Canyon Fuel Company, LLC  
Soldier Canyon Mine  
P.O. Box 1029  
Wellington, Utah 84542  
(435) 637-6360 Fax: (435) 637-0108

**RE:** Chapters 2 and 3, Canyon Fuel Company, LLC, Soldier Canyon Mine, C/007/018  
Task ID # 1665 and # 1668

Mine: Soldier Canyon Mine

Title: Revisions to Chapter 2 and 3

Figure 3.41-1

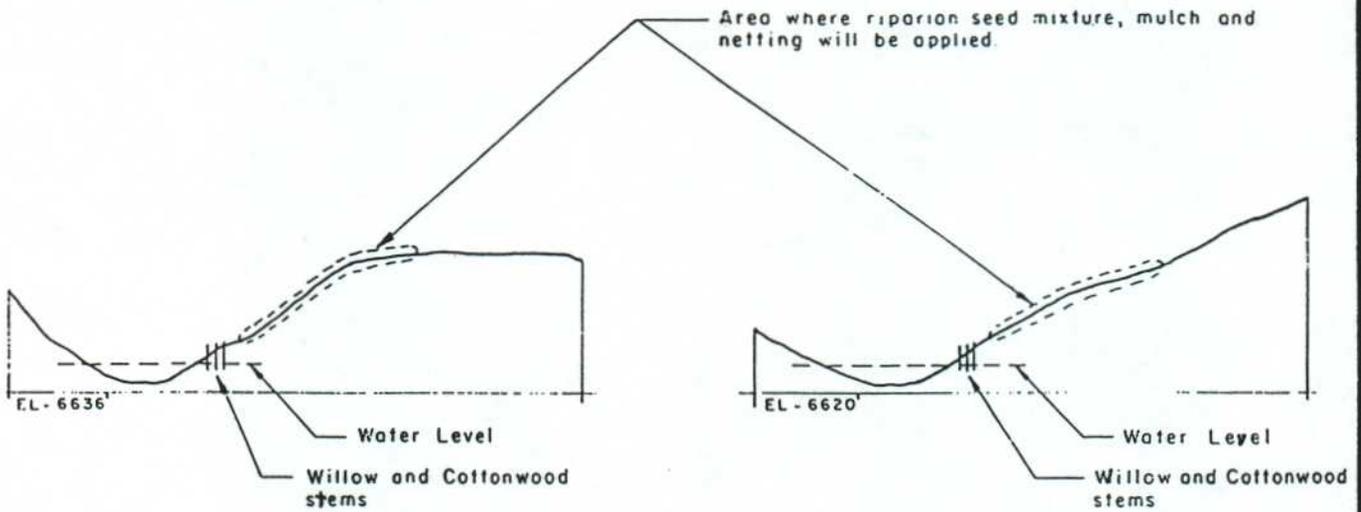
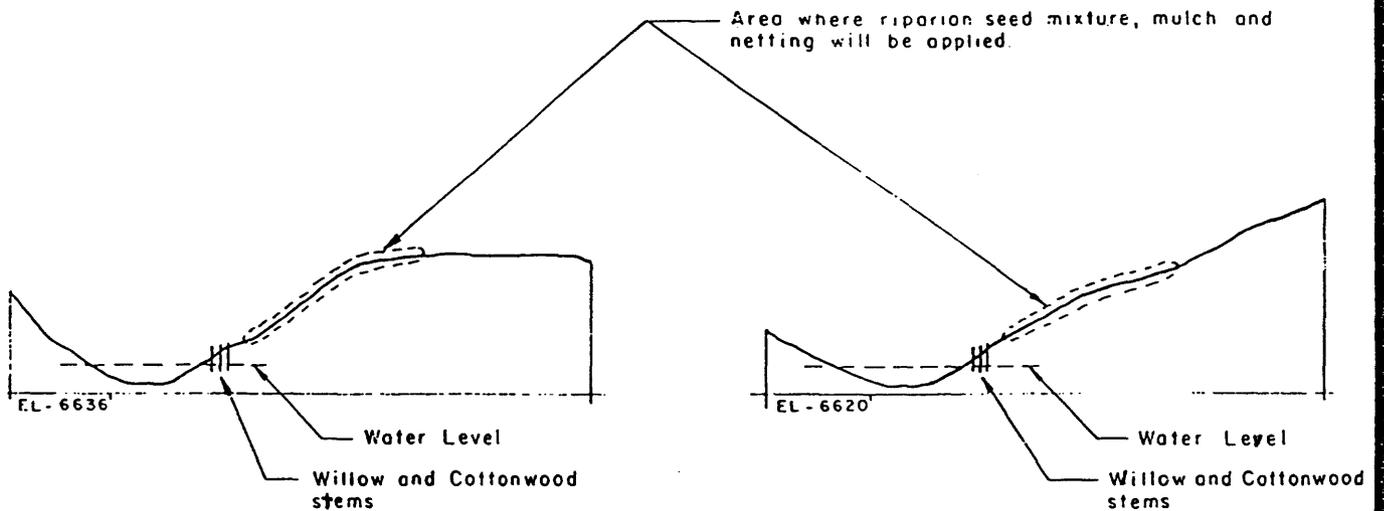
The riparian zone to be reclaimed on the mine site exists at the central mine facilities area and covers approximately 2.4 ac. The area will be graded, resoiled, sampled, fertilized (as required), seeded and mulched. The seed mixture to be planted is listed under Sec. 3.41.21. In addition, willow (*Salix*) and cottonwood (*Populus*) seedlings will be planted. Figure 3.41-1 depicts typical seedling planting plan layout.

~~At each individual planting sites, a circular area (planting circle) will be cleared of mulch materials or inhibiting debris. The size of the circle will be approximately 12 in. in diameter. The receiving hole will then be dug with the width of the hole at least three times the width of the root mass and deep enough so the bottom of the roots will be placed on undisturbed soil and the root collar will be at or above the level of the surrounding soil. depth of the hole extending 2 to 4 in. deeper than necessary for planting. The hole will be of sufficient size to allow positioning the seedling and tamping the backfill. After the hole has been formed, it will be partially backfilled with loose soil to allow planting at the proper depth. (A small amount of phosphorus fertilizer may be mixed with the backfill materials. The seedling will then be place in the hole onto undisturbed soil with its stem vertical. and the hole one half backfilled. Root systems for bare-root trees will be spread on the flat bottom of the hole or over a shallow mound constructed in the bottom of the hole. The hole will be backfilled with loose excavated native soil, packing the soil occasionally to remove air pockets. The seedling will be watered well immediately after backfilling. Additional soil will be placed if settling occurred, once placed the wet soil will not be packed. A bed of coarse organic mulch will be spread around the tree base following planting to assist in the retention of moisture. The mulch will be kept a couple of inches away from the base of the tree (Kuhns & Rupp, 2000). The hole will then be filled with water and the remainder of the seedbed material backfilled into the hole as rapidly as possible without displacing water from the hole. The backfill will be firmly tamped around the seedling. A basin, which slopes gently from the outside of the planting circle to the seedling stem, will be formed of seedbed material to aid in water catchment and retention.~~

The riparian zone to be reclaimed on the mine site exists at the central mine facilities area and covers approximately 2.4 ac. The area will be graded, resoiled, sampled, fertilized (as required), seeded and mulched. The seed mixture to be planted is listed under Sec. 3.41.21. In addition, willow (*Salix*) and cottonwood (*Populus*) seedlings will be planted. Figure 3.41-1 depicts typical seedling planting plan layout.
